Changes to existing roundhouse structure

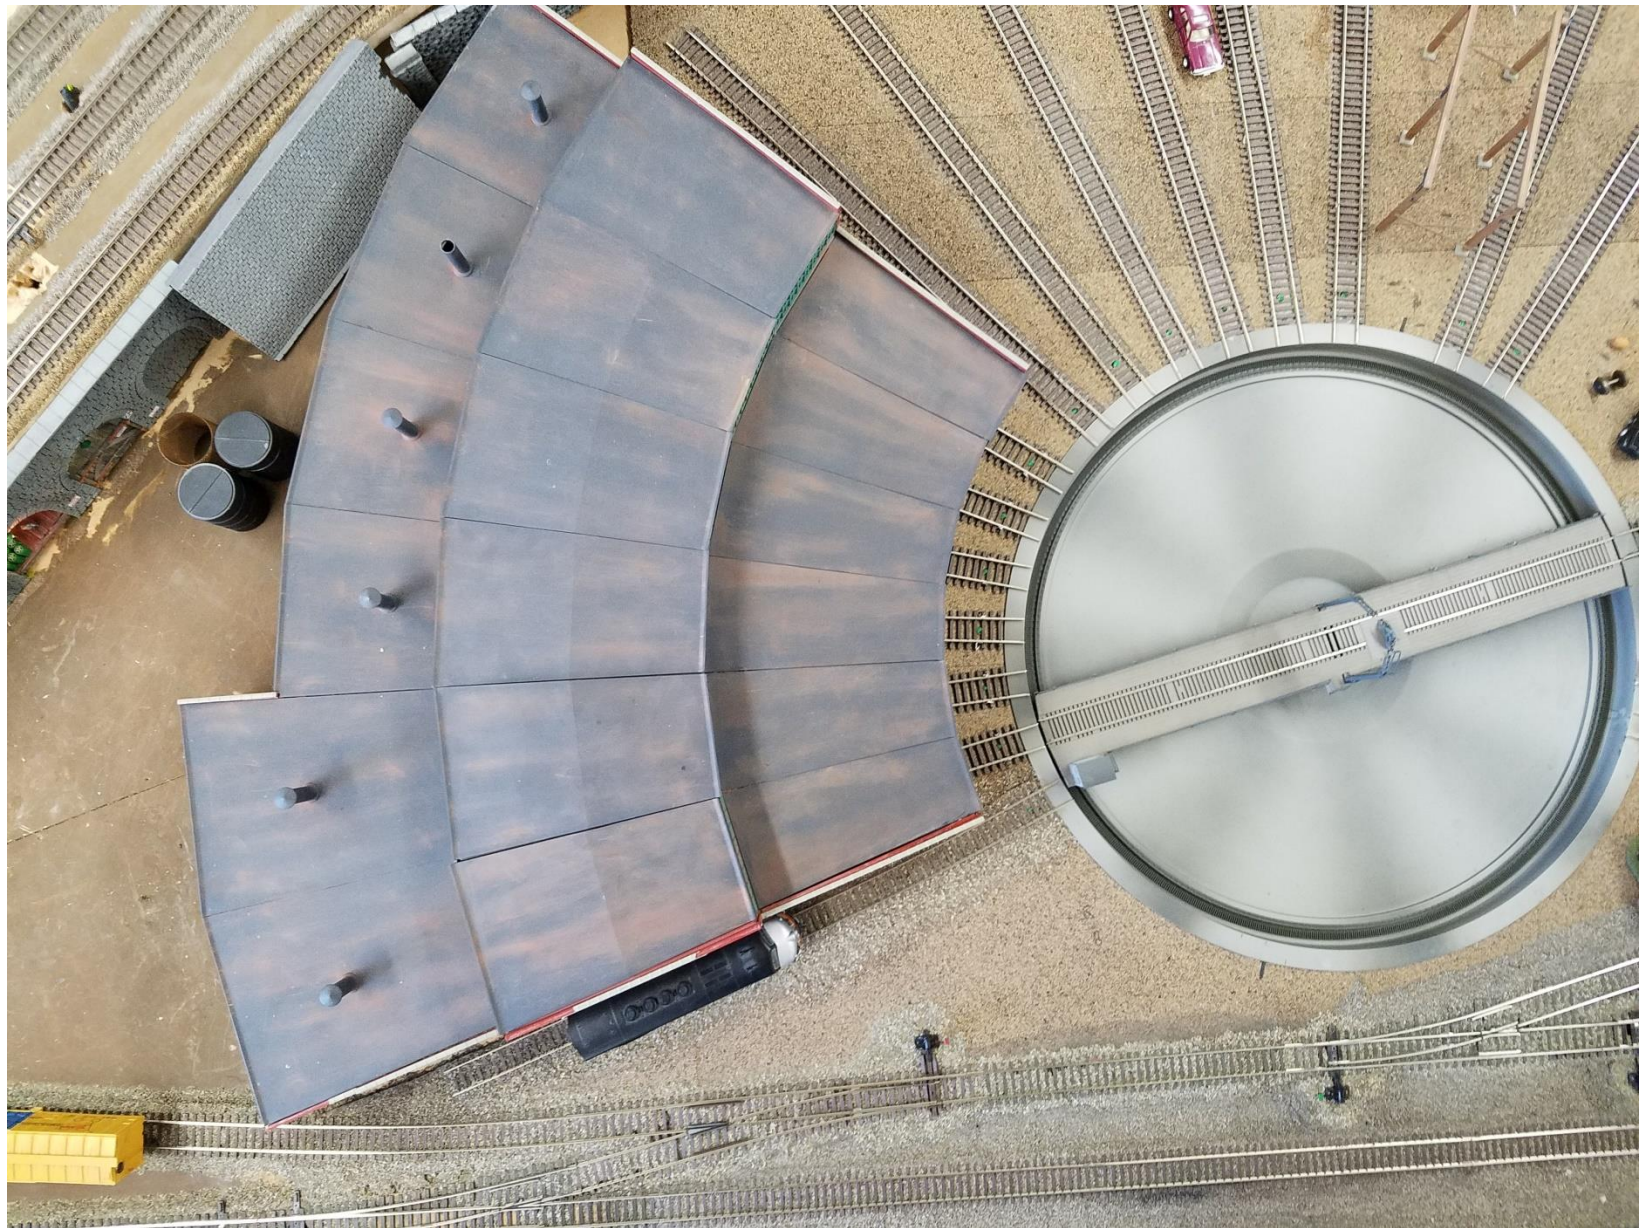
Proposal 1. - remove outside 2 stalls

Allows access at
back of
roundhouse

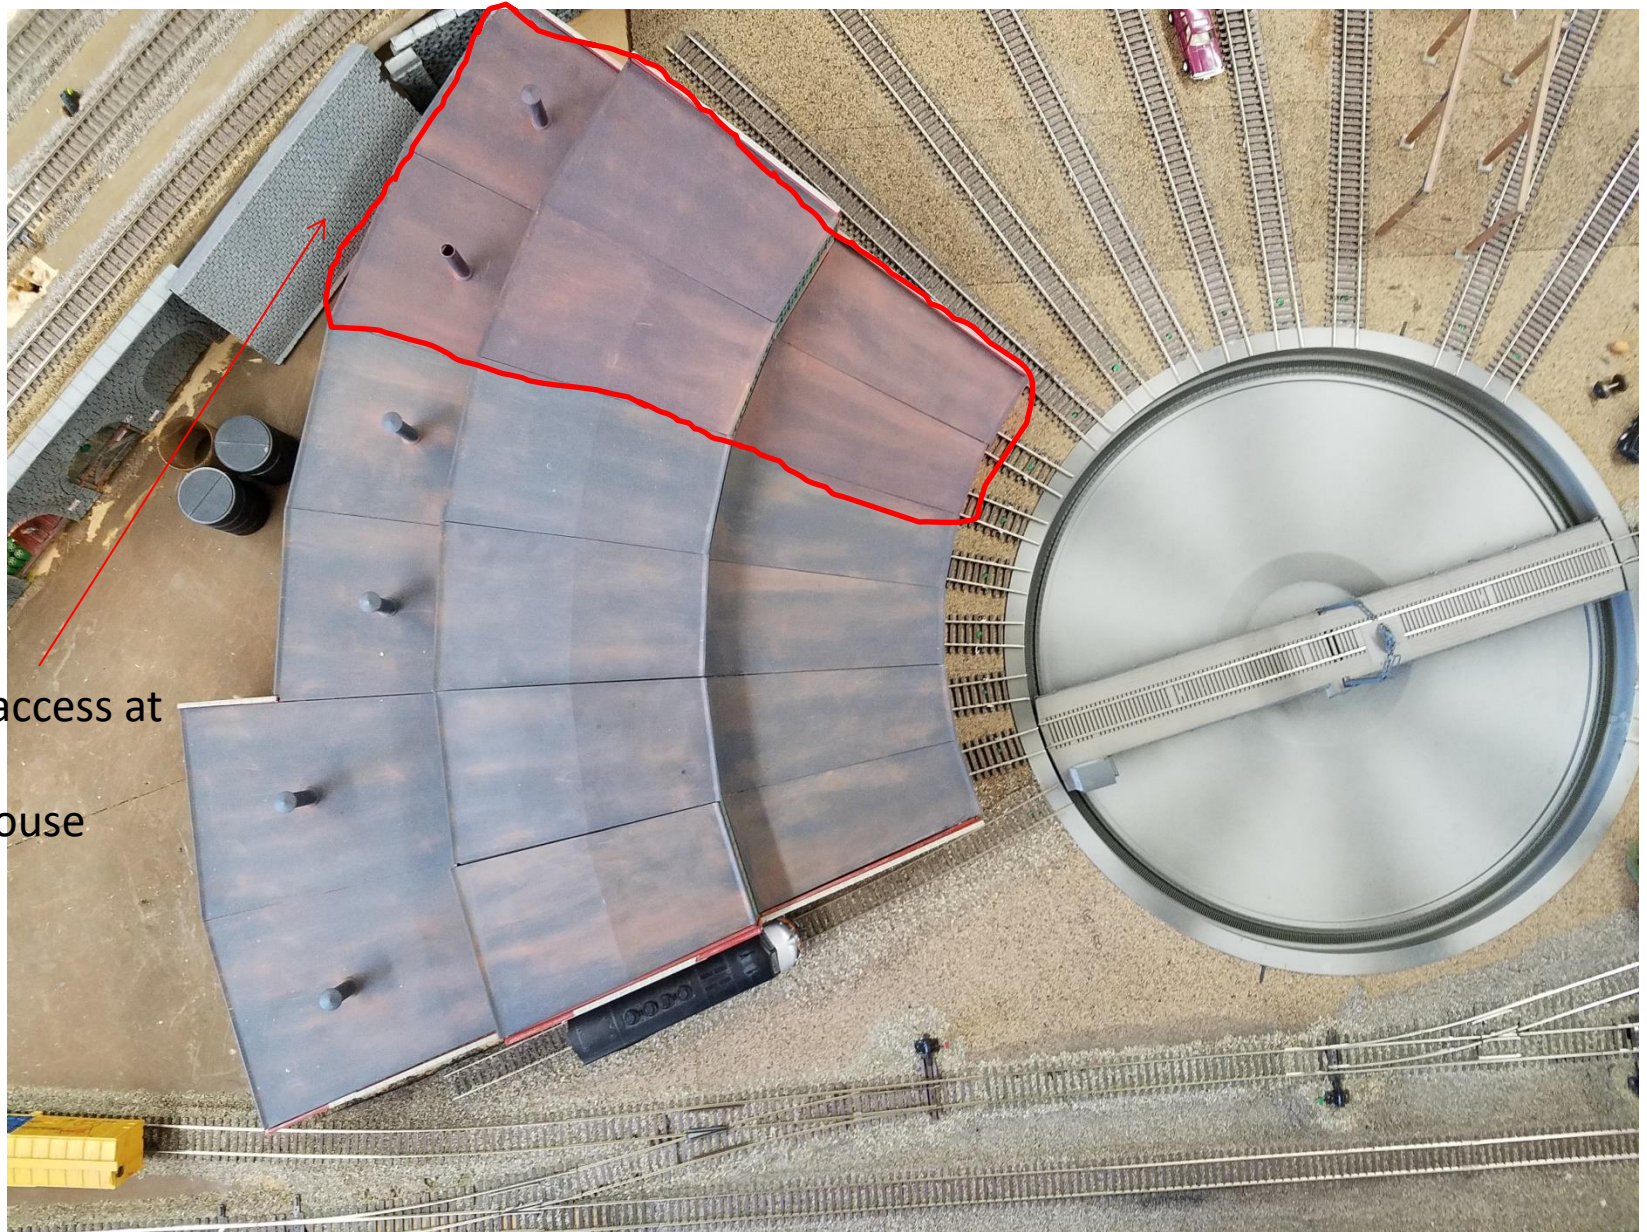
Proposal 2. Remove outside 2 stalls and cut back depth of first 2 stalls

Gives more room
for ancillary
buildings at back

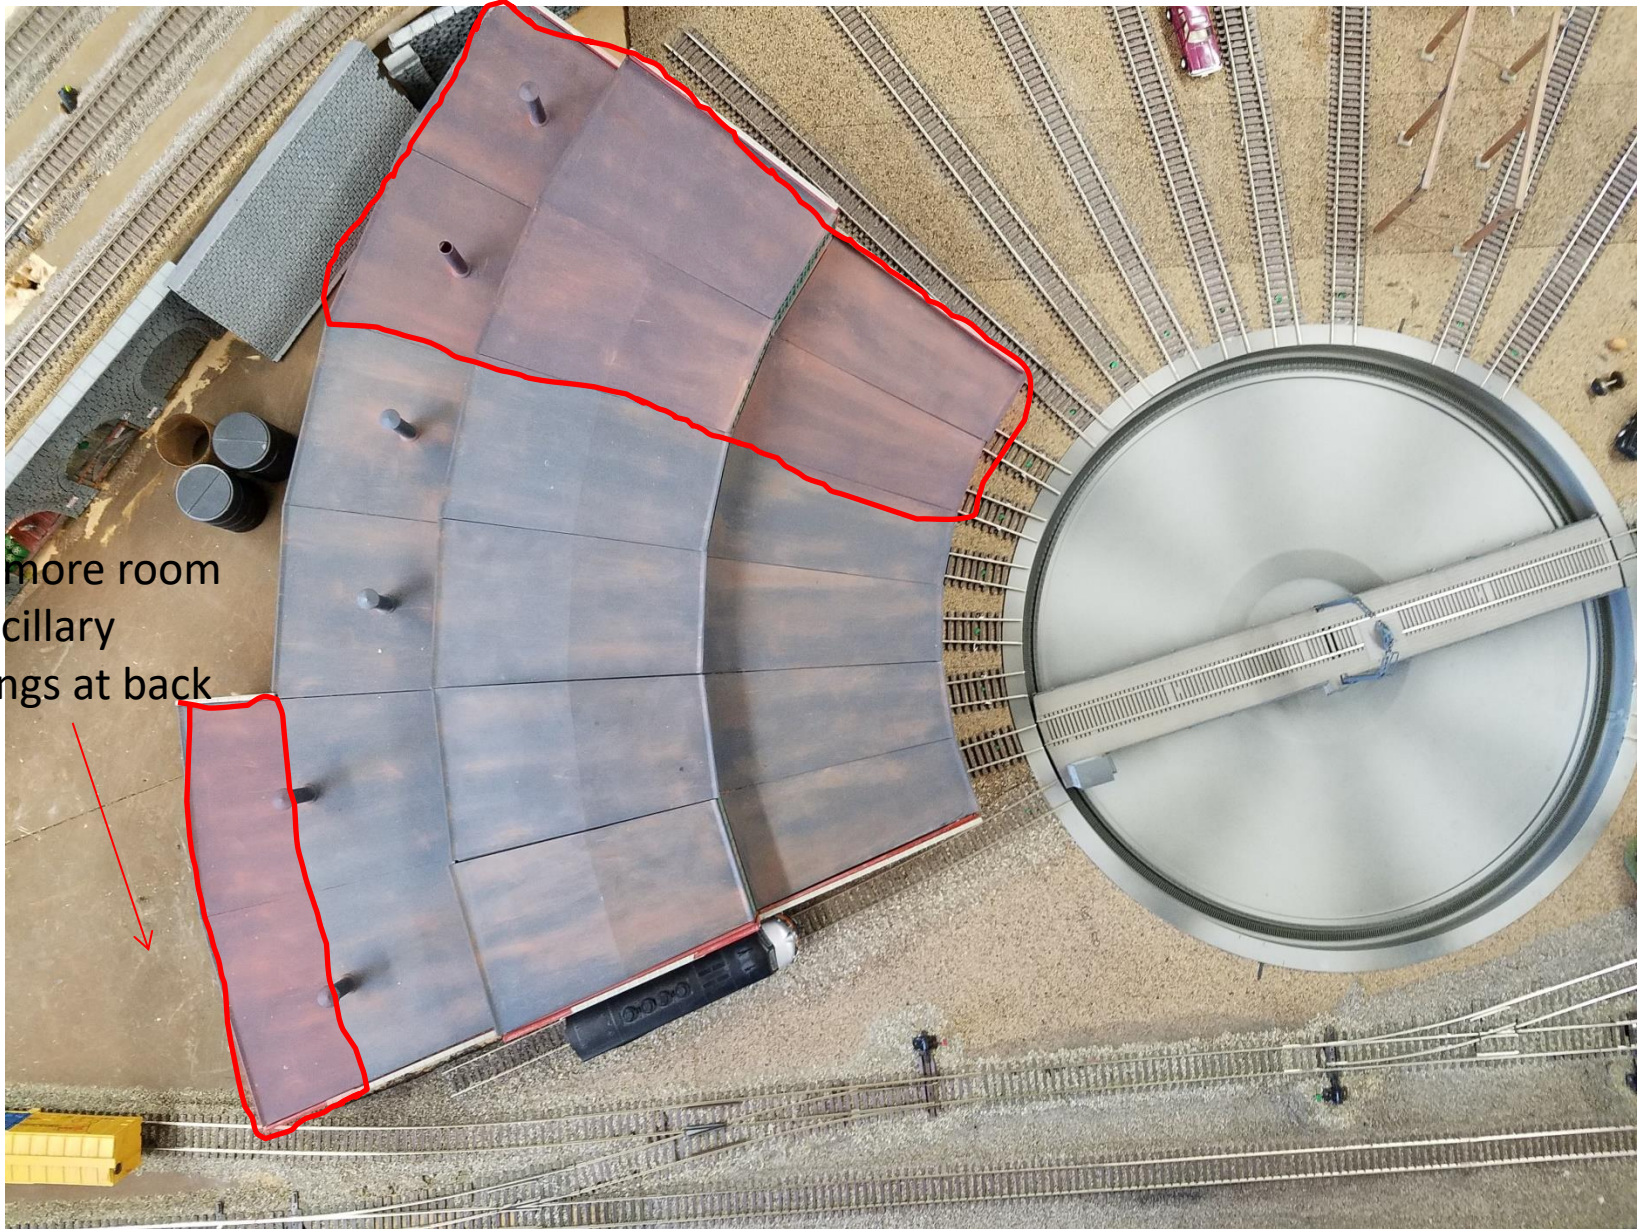
Proposal 3. remove back of stalls 5,6 and back of stalls 1,2
